36-I-1
92 Portland Street
Building Addition
Bubba's

RE: Bubba's Building Addition / 92 Portland Street
Revised Application #2004-0221, CBL #036 I001001

TO: Ethan Macomber Boxer – Planner
FROM: Jim Seymour – Development Review Coordinator, Sebago Technics, Inc.
RE: Bubba’s Sulky Lounge – Parking & Site Improvements TEL: 856-0277
92 Portland Street, Portland, ME
DATE: August 25, 2005

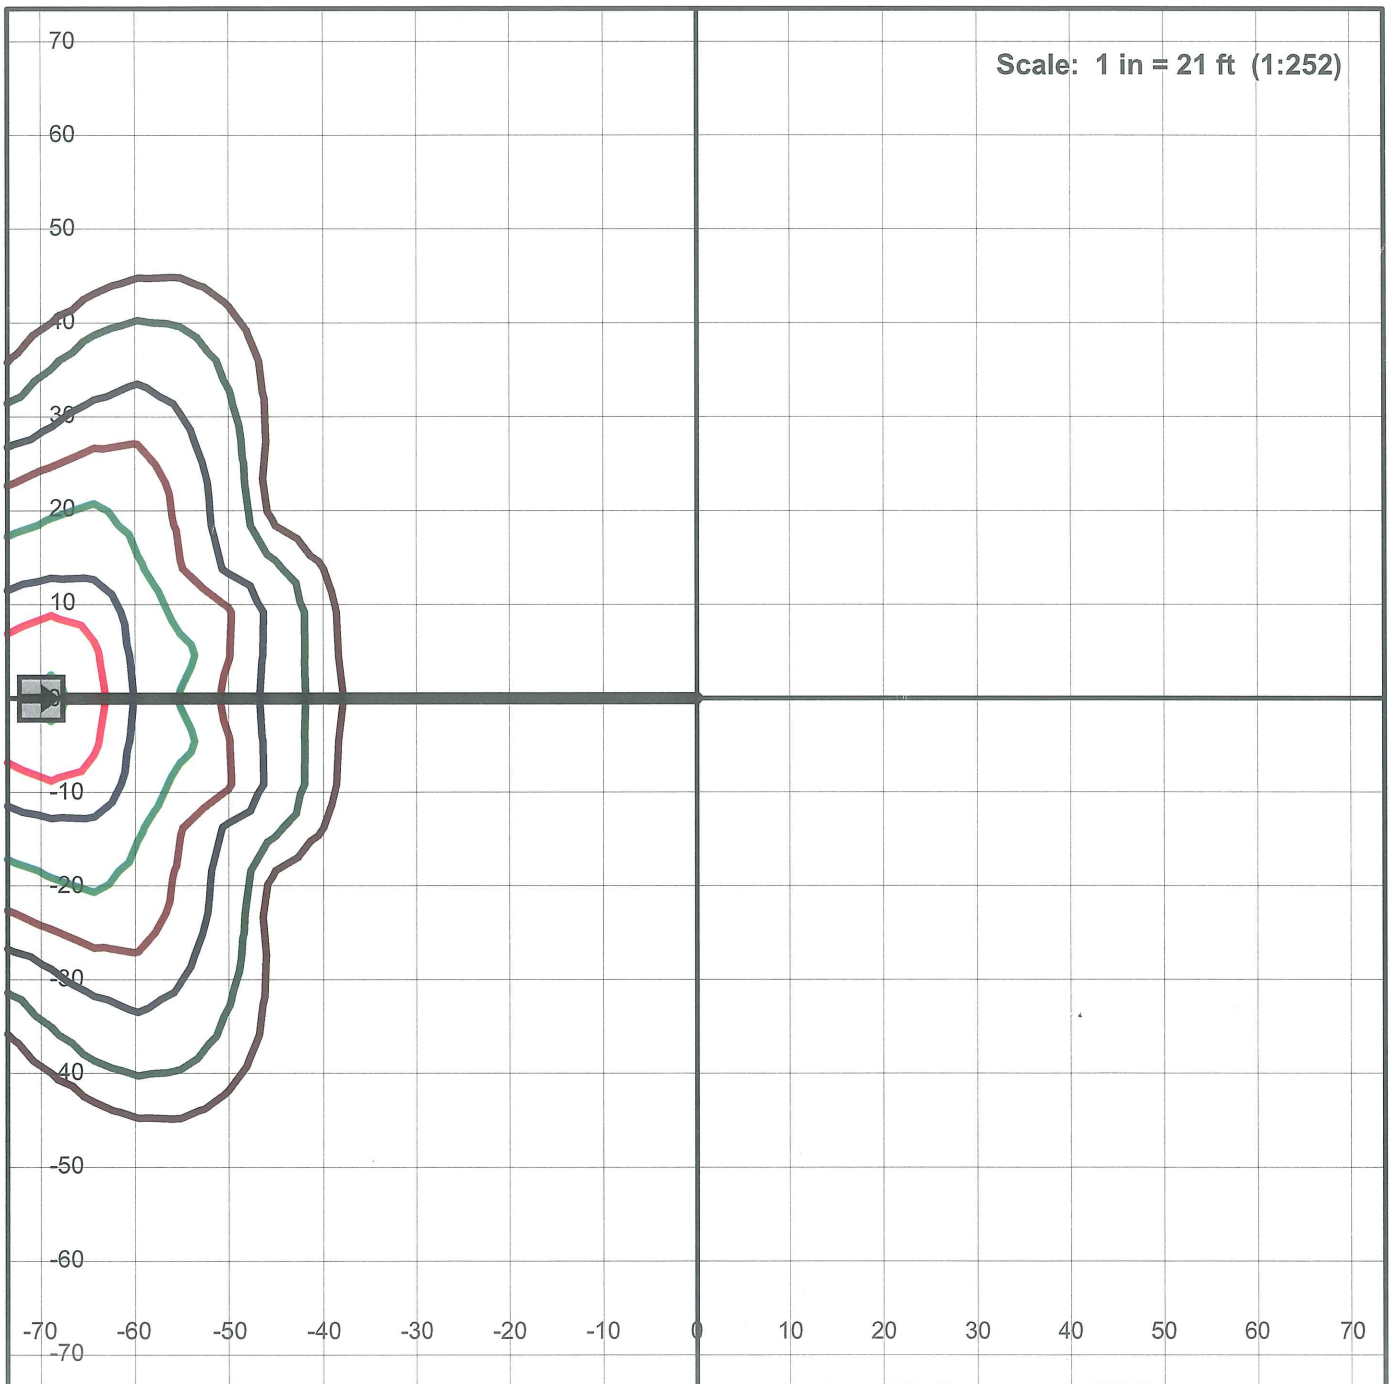
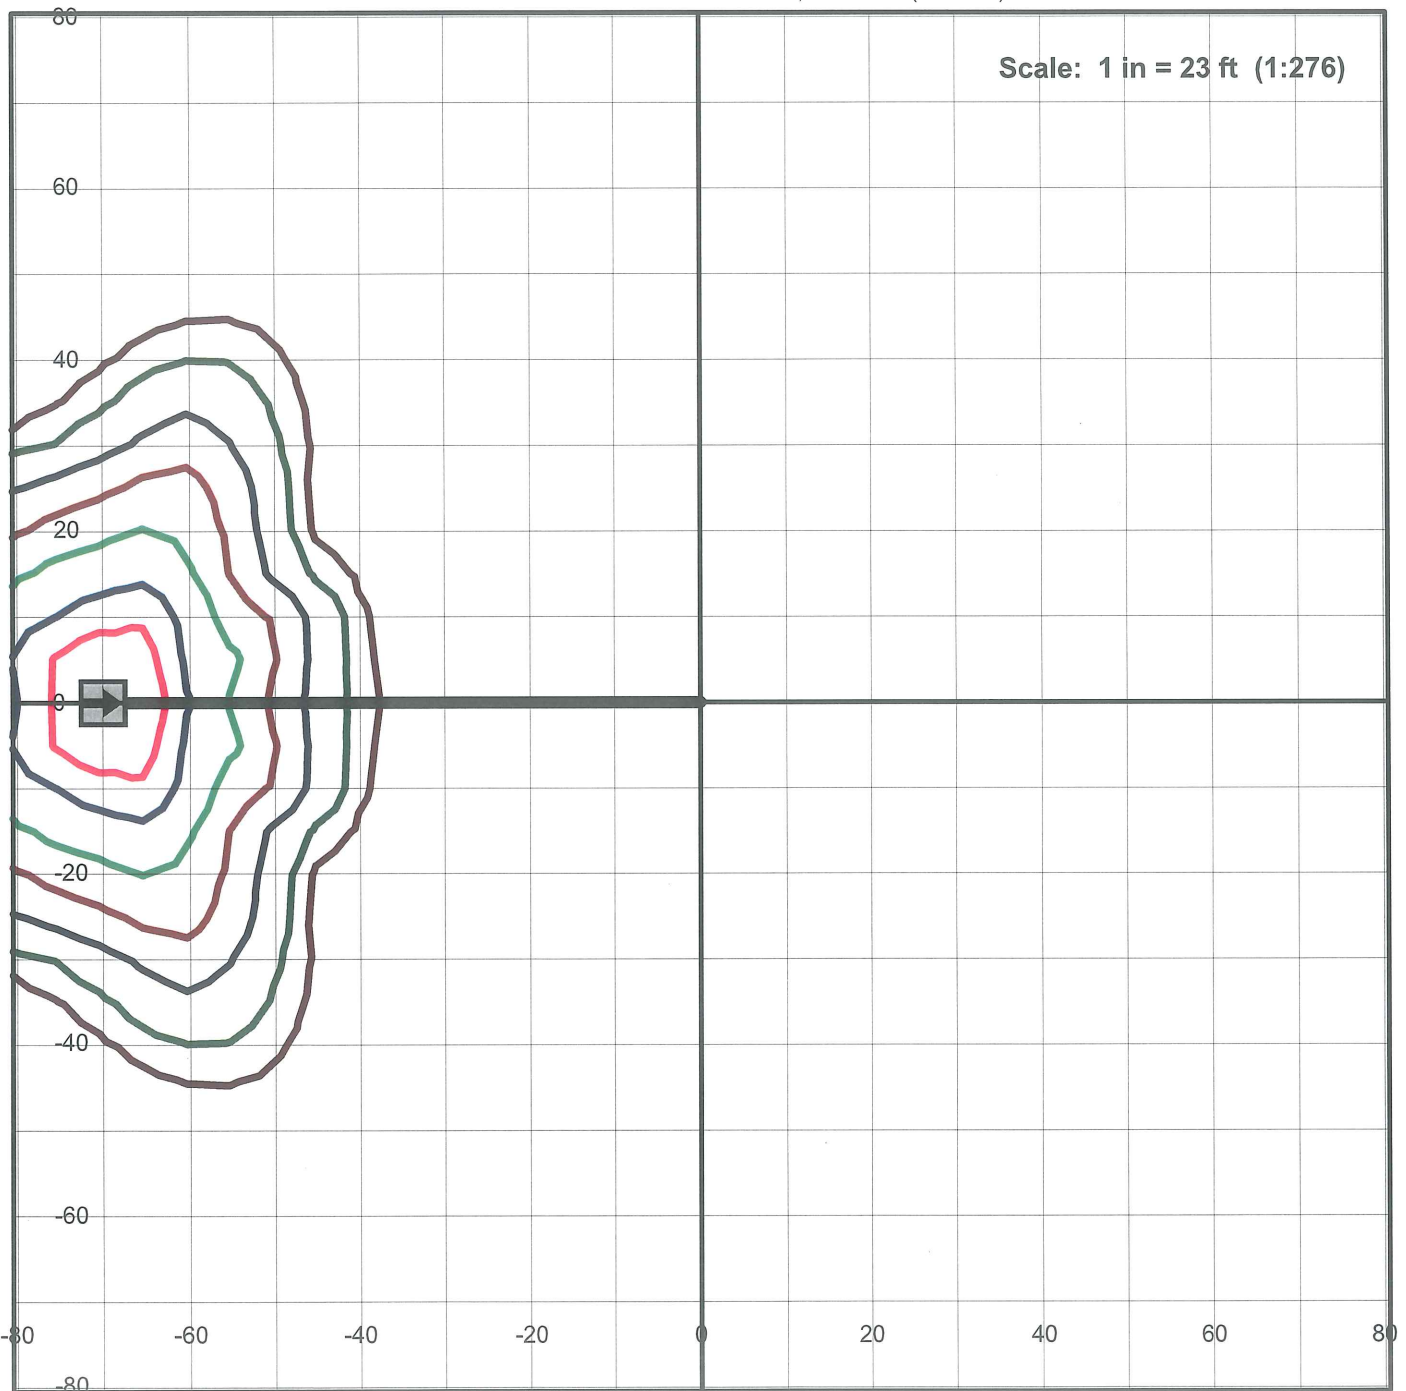
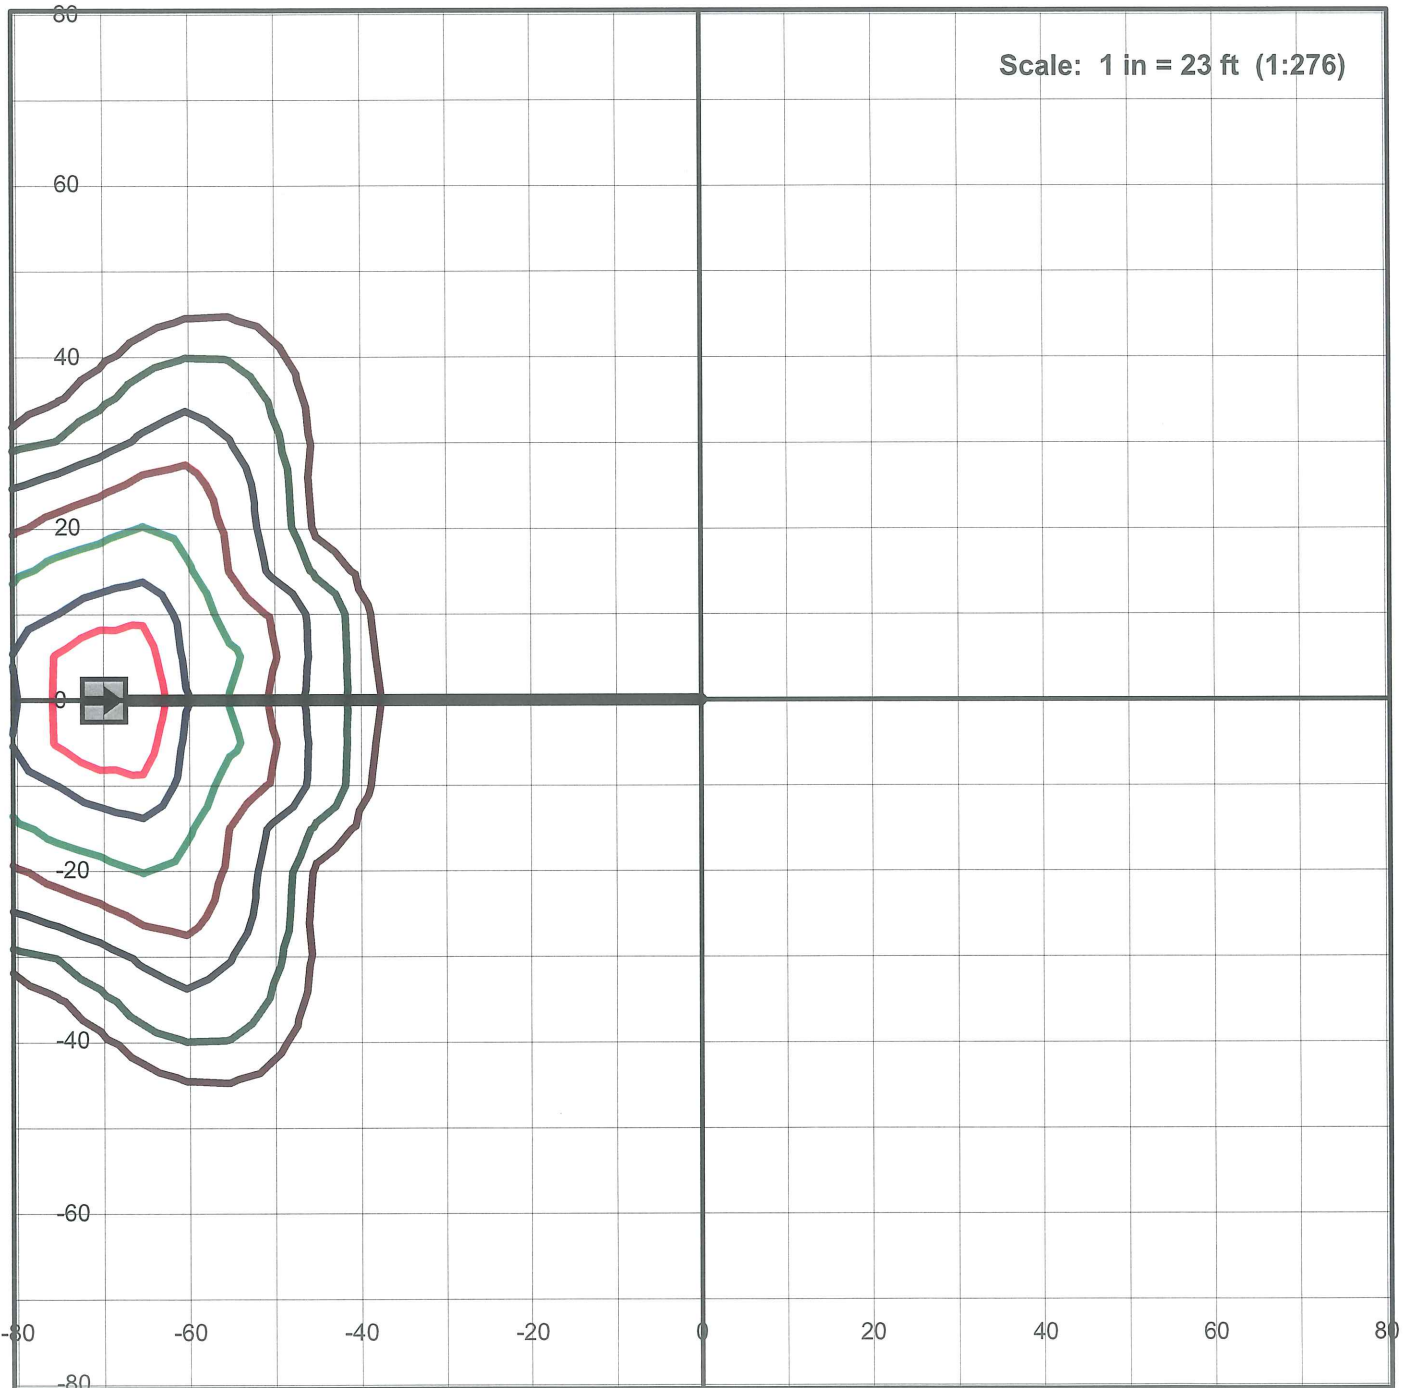
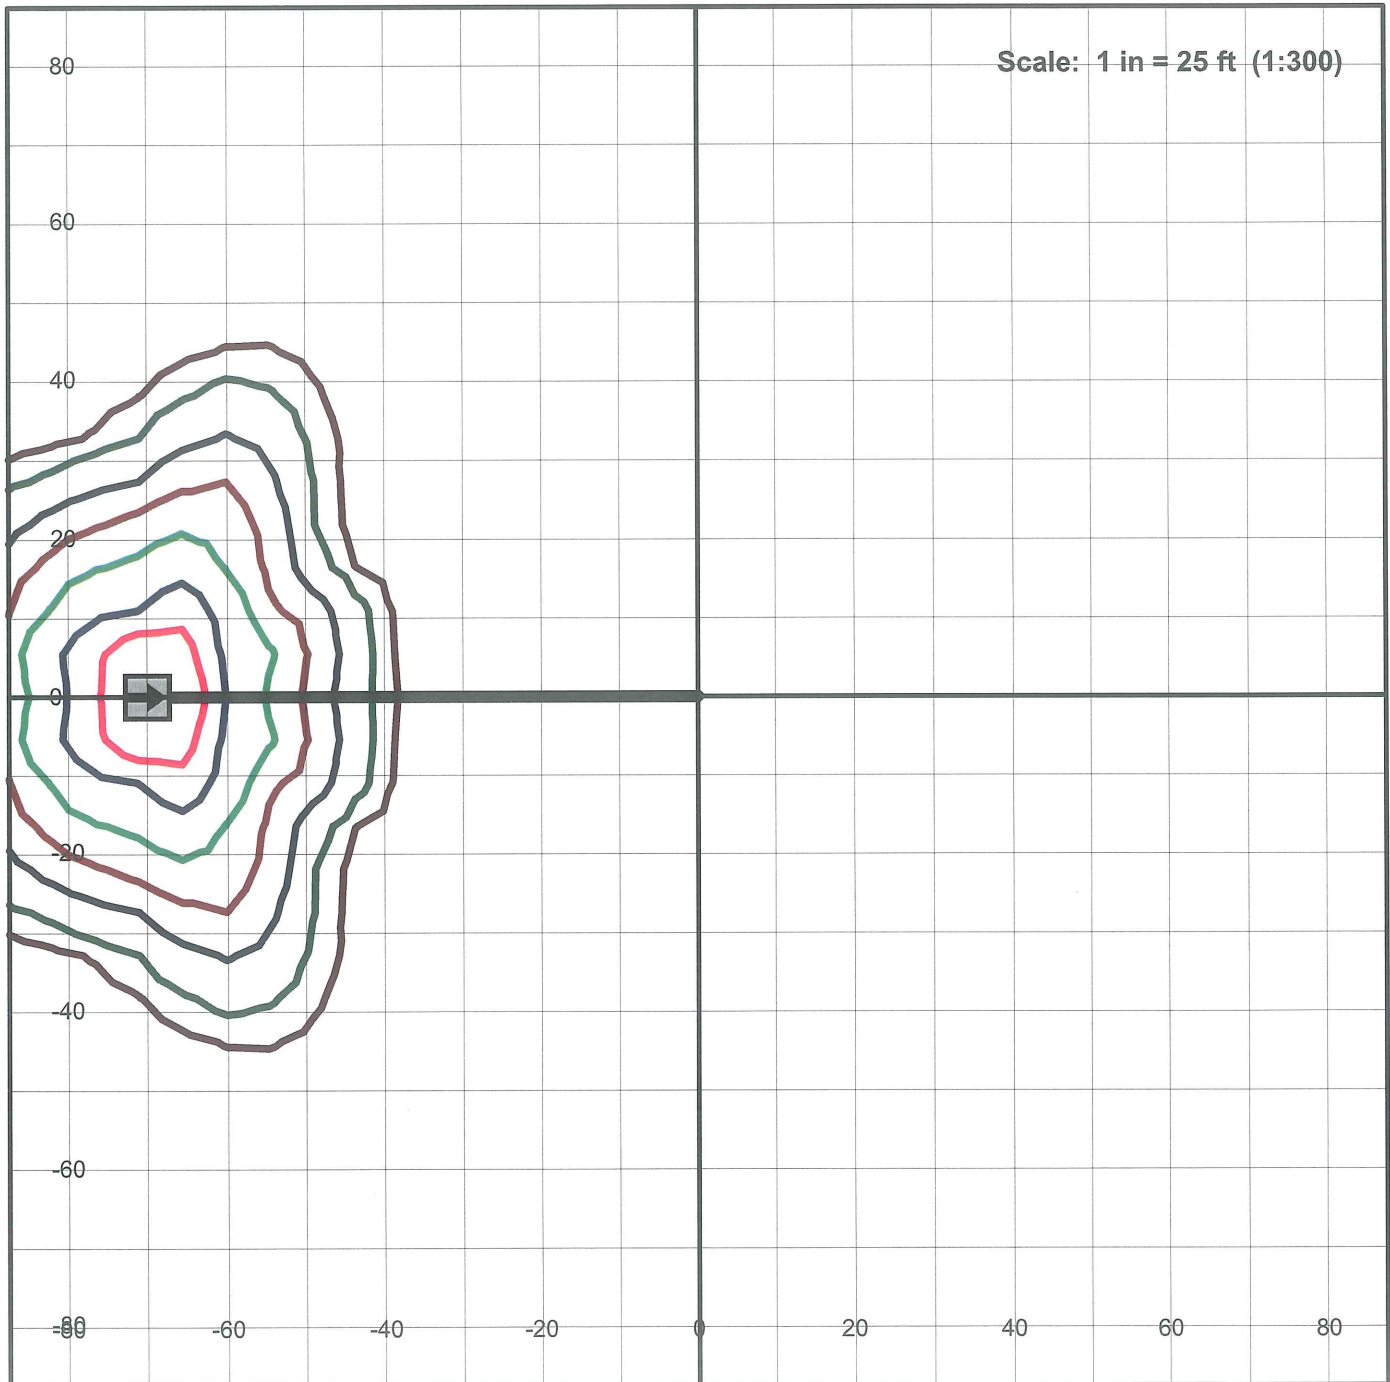
I have looked at the lighting plan. I would like to see the catalog cut of the the two fixtures that are proposed. There are a couple of hot spots under each light. I wonder if a 150 rather than 175 wattage bulb would bring the plan into conformance.

Lastly, I believe the City wanted the CMP lights on Portland Street and Mechanic Street removed. The plans notes each light with a delete, but it is unclear to me that those lights are to be removed.

I have enclosed a new photometric plan adding one more pole. This should address your concerns about the dark area in the driveway. The few hot spots in front of the fixtures are because of the houseside shields. This is typical of this fixture and shield as the light is thrown forward and doesn't escape to the rear of the fixture. The fixture will meet your light trespassing ordinance. If the wattage of the fixture is reduced to 150 watts we will no longer be in compliance with the foot candles required by the IES standards.
